## 5.0 Reactor Coolant System and Connection Systems

### 5.1 Summary Description

The information in this section of the reference ABWR DCD, including all subsections and figures, is incorporated by reference with the following departures.

Figure 5.1-1 Rated Operating Conditions of the ABWR

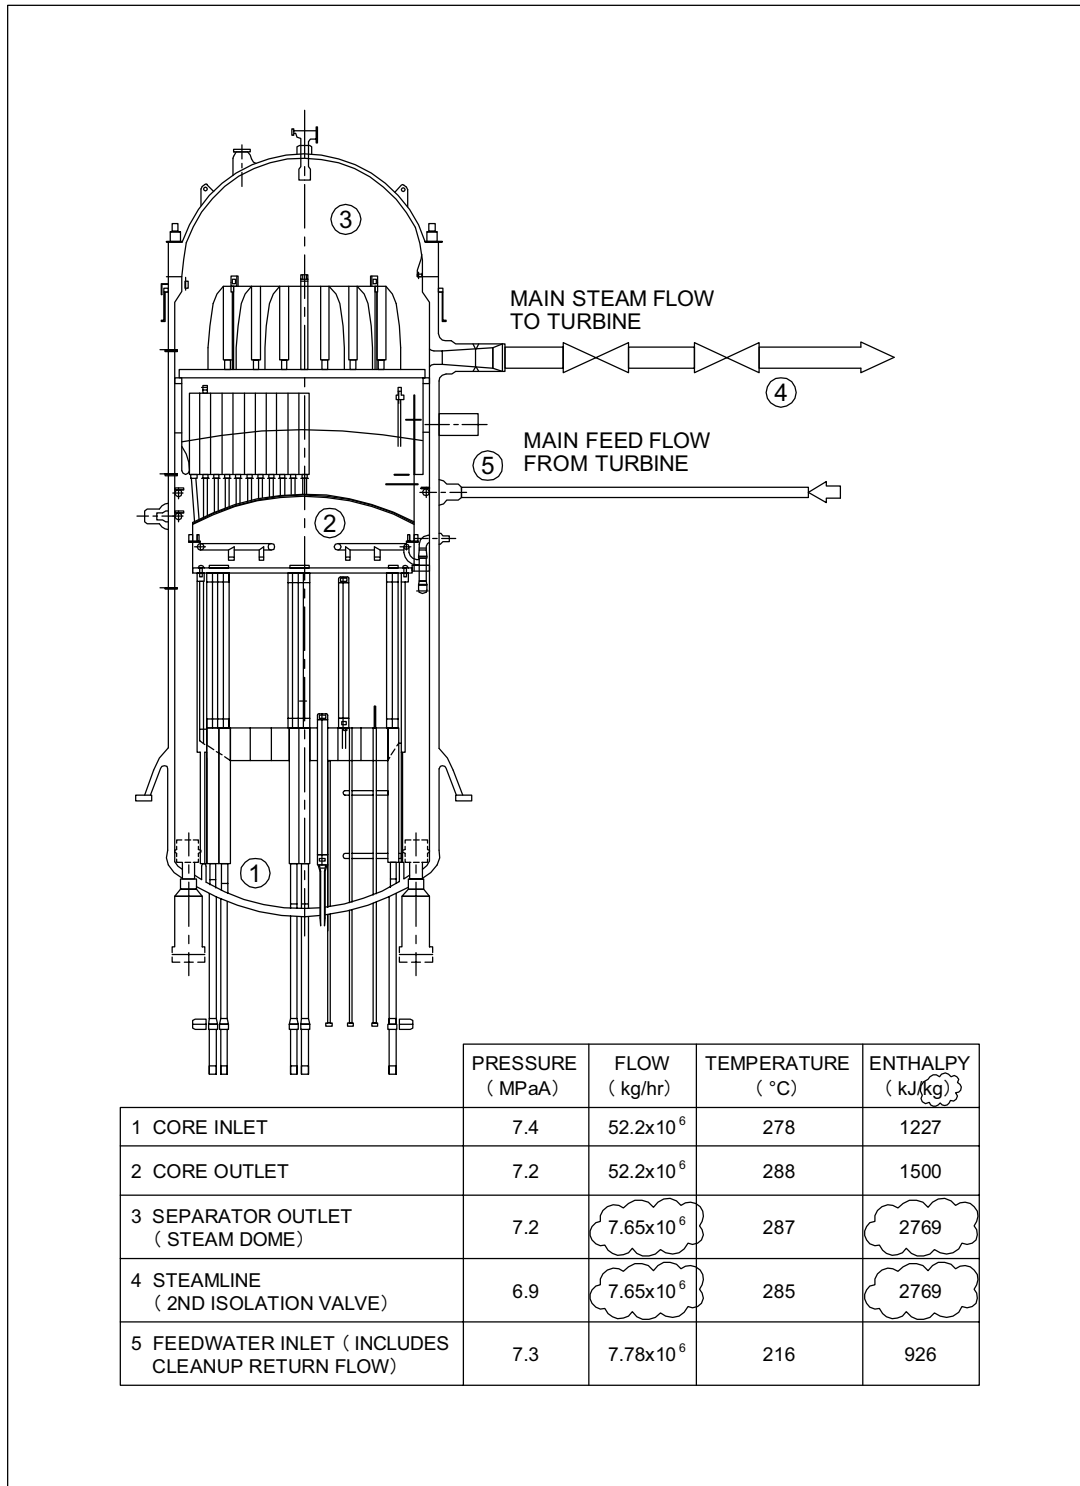
STP DEP 10.1-3 (Figure 5.1-1)
